PLANNING COMMISSION AGENDA

Planning Commission Meeting
6:00 PM Thursday, January 12, 2017

VILLAGE OF SOUTH LEBANON MEMORANDUM

TO: Planning Commission
FROM: Jerry Haddix, Village Administrator
RE: Case 17-02P, Site Plan Review for Patel Convenience Store
DATE: January 9, 2017

Drawn By	DF	Date	10/28/16	Project No.	06308.03	Sheet No.	L100
Project Mgr.	JW	Scale	1" = 20'	Points D.B.	06308 TBC		
CAD				06308036-PLA	X-Ref.	06308034-IMP-001	File No. 06308

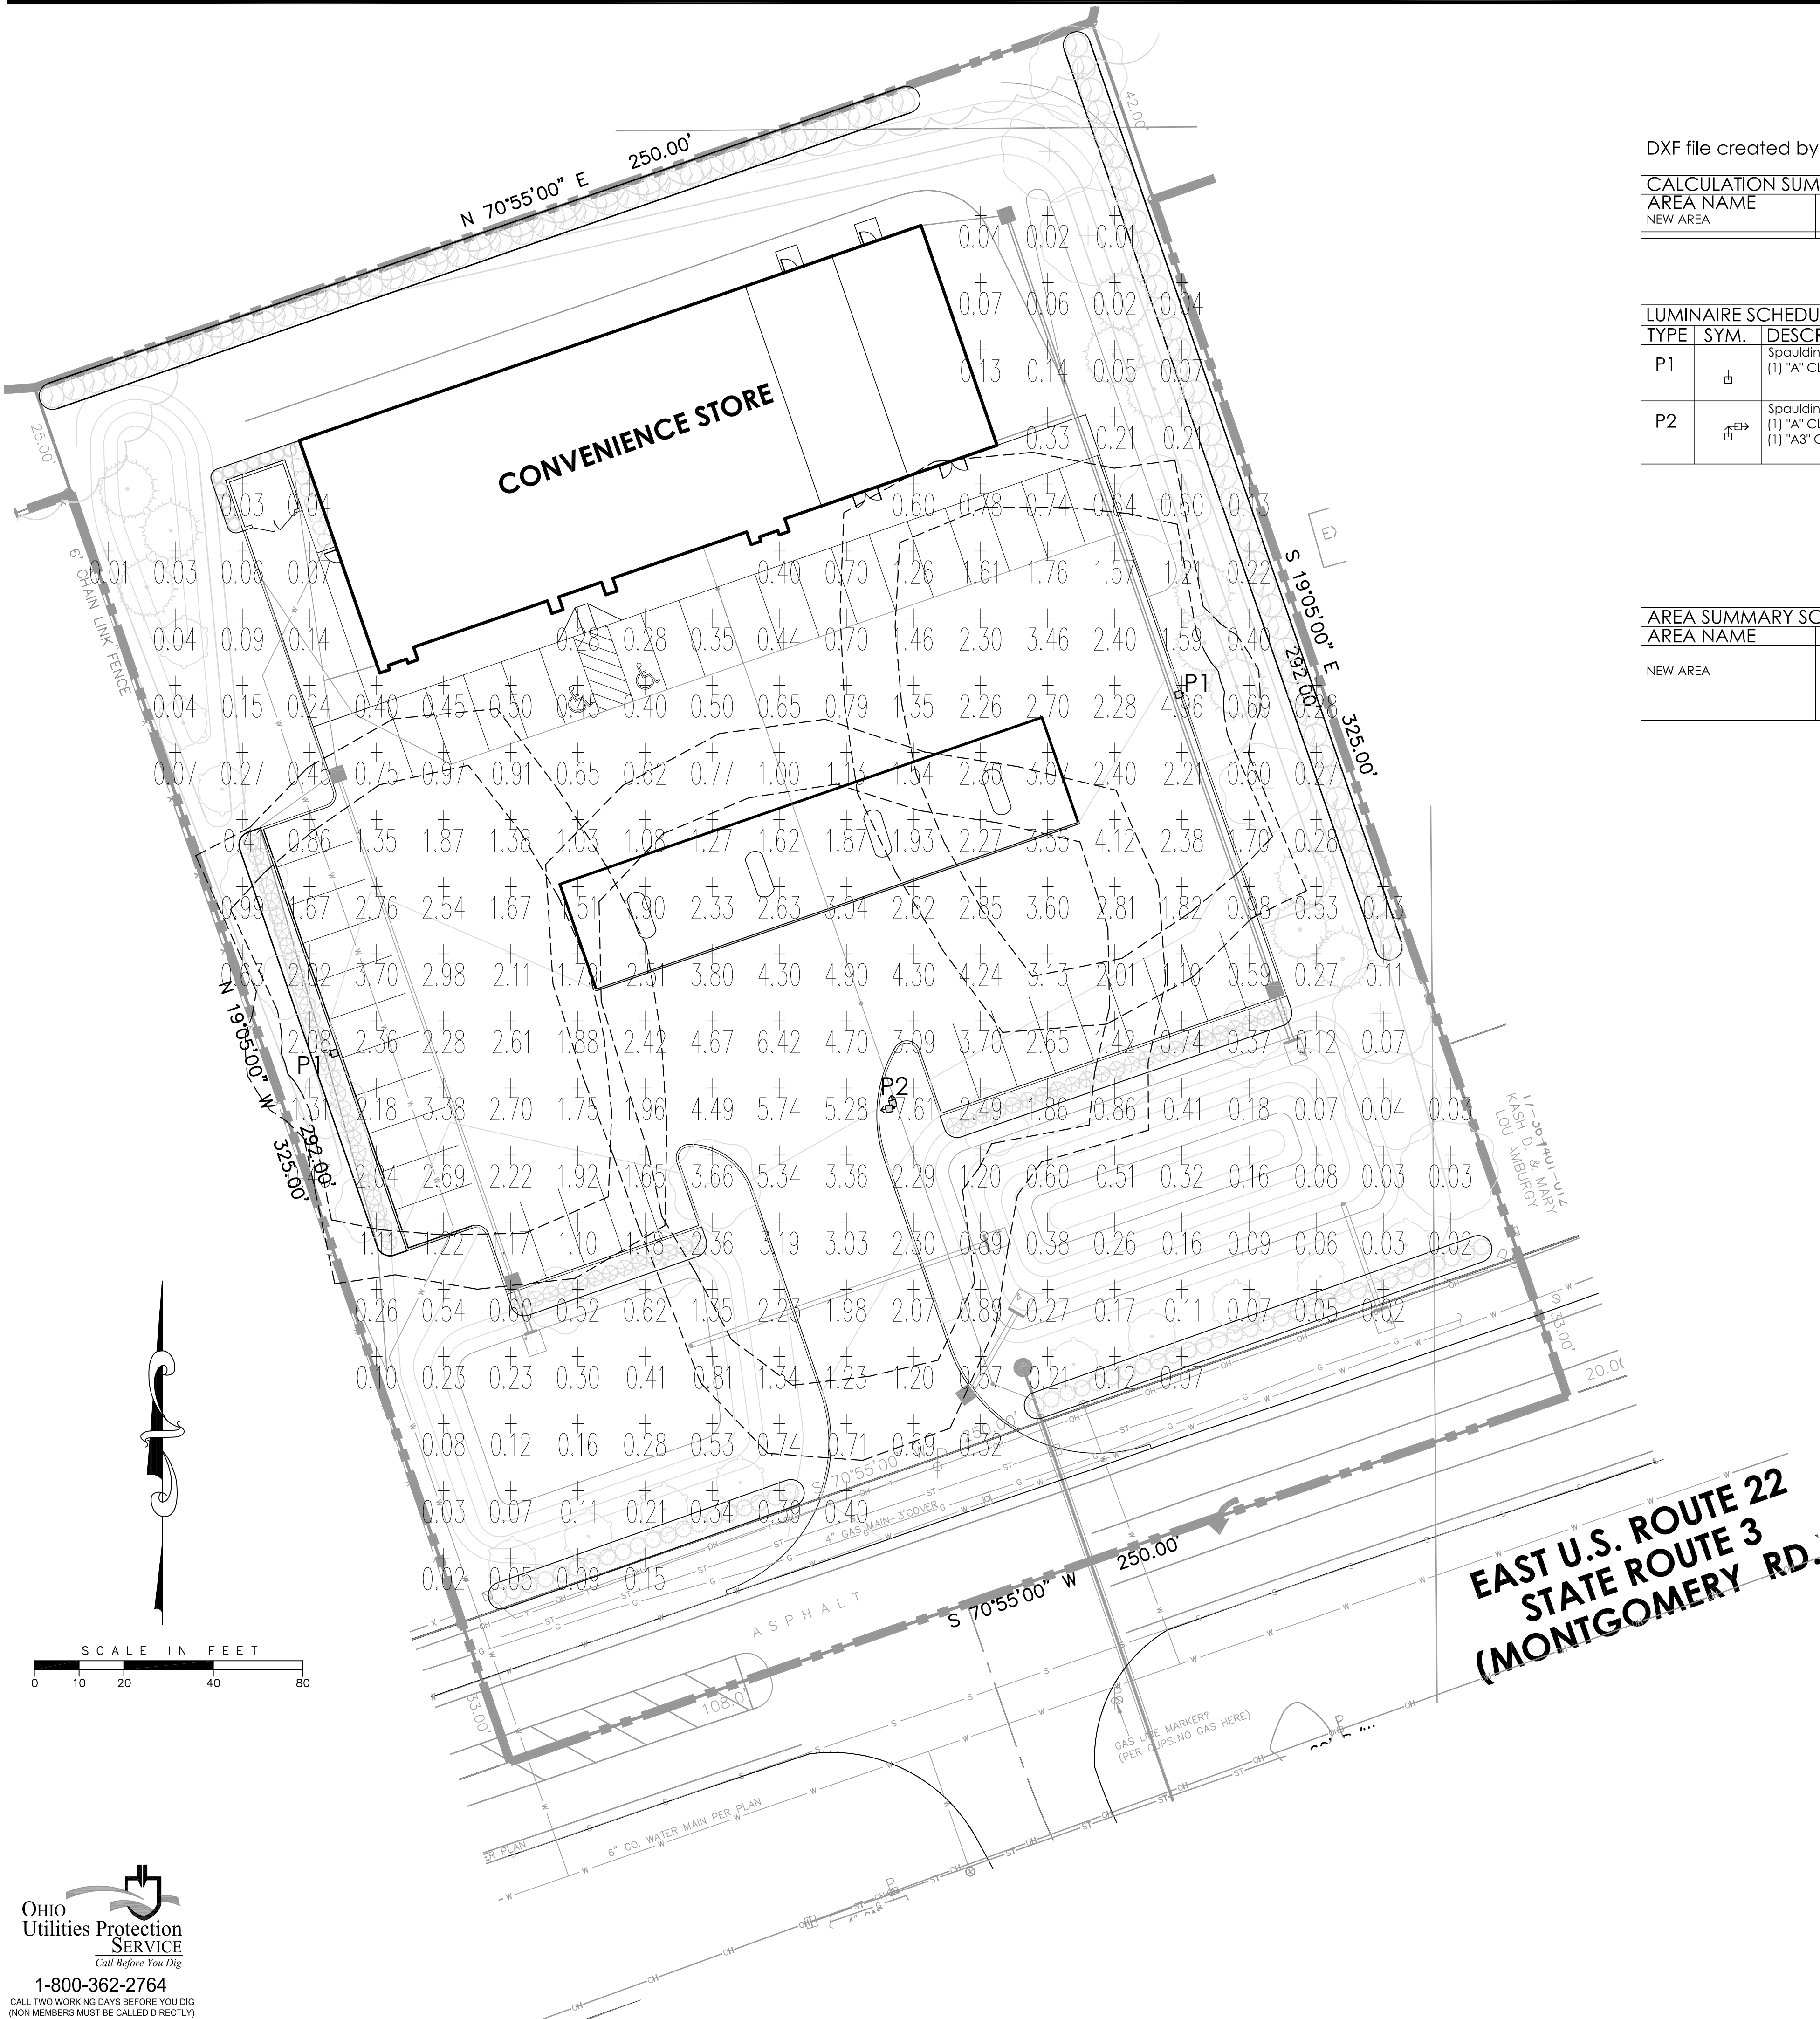
8. Appearance	Sec 15.18.21.3	
a. Compliance with Sec 15.18.21.3	<input checked="" type="checkbox"/>	
9. Landscape Plan	Sec 15.17	
a. Sec 15.17.4 (a-b)	<input type="checkbox"/>	Front yard of all non-residential uses shall be planted with sod or hydro-seeded. Per the amount of unpaved areas there should be 14 evergreen trees.

f. Sec 15.17.9.1	<input type="checkbox"/>	Not applicable
g. Sec 15.17.9.2 (a-c)	<input type="checkbox"/>	Provide the calculation that indicates the required

landscaping square footage
h. Sec 15.17.10 (1-4)	<input type="checkbox"/>	Provide the calculation that indicates the required landscaping square footage

c. Loading Areas	<input type="checkbox"/>	Please provide/show the two required off-street loading spaces (12'x65') and the corresponding landscaping
d. Dumpster Enclosure	<input checked="" type="checkbox"/>

Drawn By	DF	Date	10/28/16	Project No.	06308.03	Sheet No.	L200
Project Mgr.	JW	Scale	1" = 20'	Points D.B.	06308 TBC		
CAD				06308034-IMP-00	File No.	06308

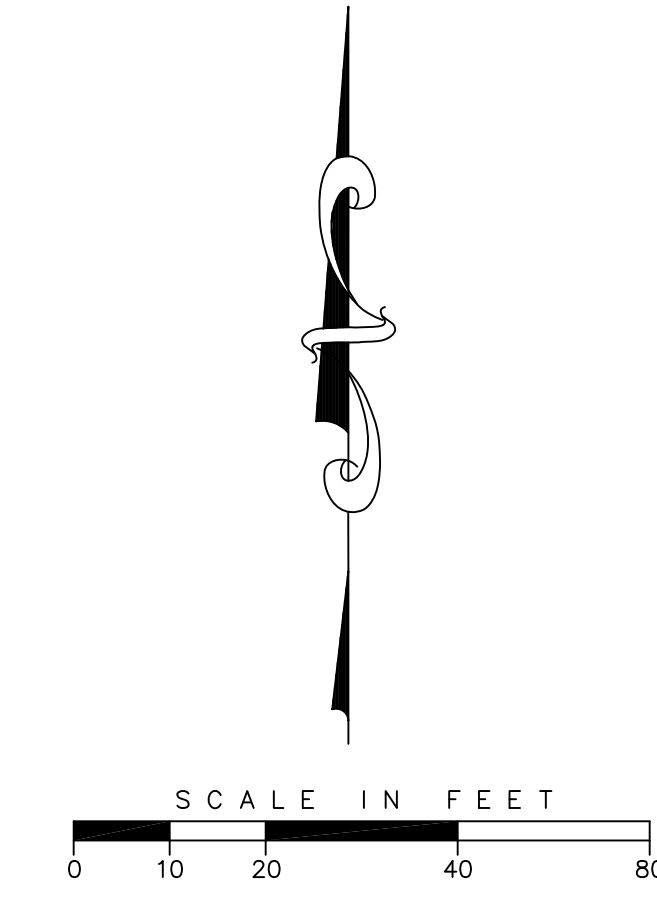
c. Sec 15.18.20.3 (a-x)	<input type="checkbox"/>	Note (b) – show front yard setback dimension Note (k) – Both P1 light pole locations allow light to portray over the property line. Revise and photometric sheet with method of shielding lights from shining off the site Note (u) – show an easement on the property for the sanitary sewer main extension.

a. Erosion Control Plan	<input checked="" type="checkbox"/>	
7. Lighting Plan	Sec 15.18.21.14	
a. Compliance with Sec 15.18.21.14	<input type="checkbox"/>	Both P1 light pole locations allow light to portray over the property line (revise) and update photometric sheet to show the light levels beyond the property lines
